AN1006: Differences Between Si534x/8x Revision B and Revision D Silicon

This document highlights differences between Revision B and Revision D silicon for the following part numbers:

SUMMARY

Figure 1.1. Device Revision D

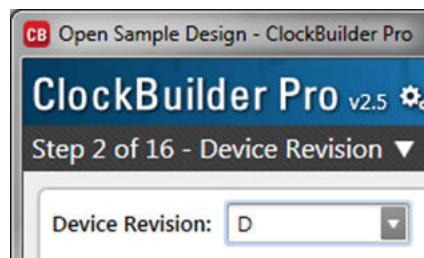
ClockBuilder Pro (CBPro) version 2.9 or later supports both Revision B and Revision D of Si534x/8x. Selection of the target device revision is done in Step 2 of the configuration Wizard:

The default revision is "D" for all newly created designs.
